The purpose of this Addendum No. 1 below hereto is to provide answers to questions raised and to confirm certain additions/changes/information all of which form part of the ACAN. All other terms and conditions of the subject ACAN remain unchanged and in effect

PROJECT DETAILS:

CLARIFICATIONS:

(a) Texture Quality for Visualization Model

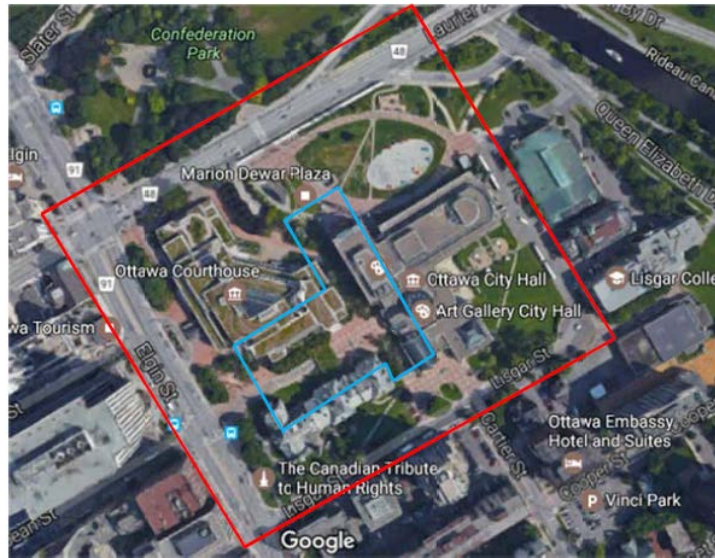
The Lidar-based visualization model must include textures that are similar to what is shown in picture (a) below.
